DRAWING AMENDMENTS

FIG. 1.

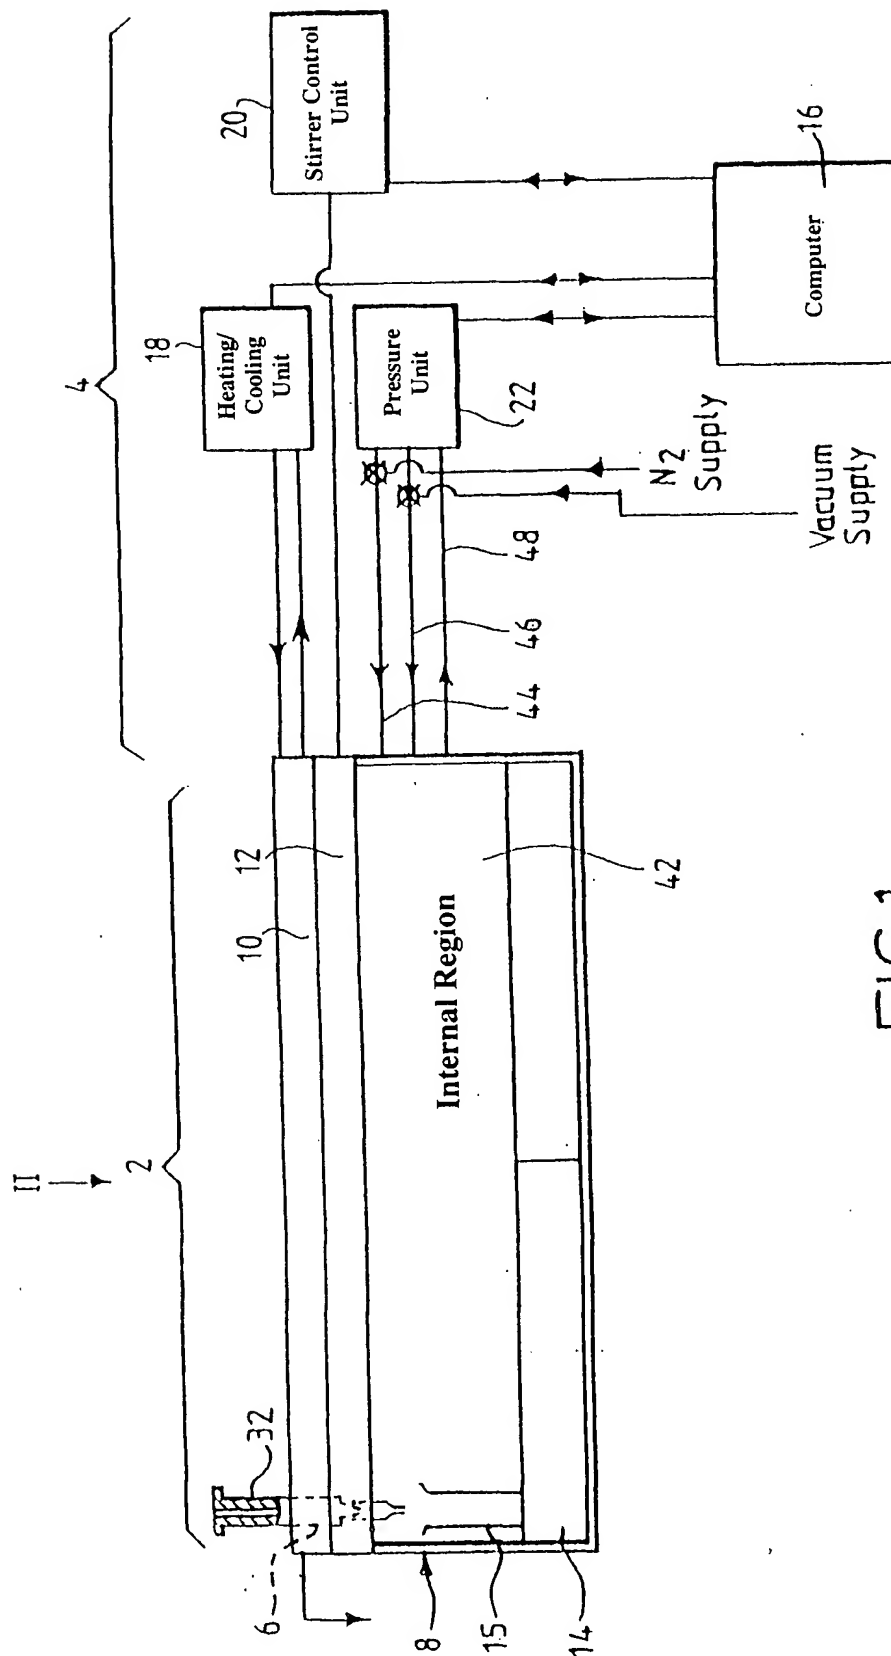
Figure 1 has been amended so that boxes 16, 18, 20, 22, and 42 are labeled by function as follows:

- Box 16 is now labeled "Computer";
- Box 18 is now labeled "Heating/Cooling Unit";
- Box 20 is now labeled "Stirrer Control Unit";
- Box 22 is now labeled "Pressure Unit"; and
- Box 42 is now labeled "Internal Region".
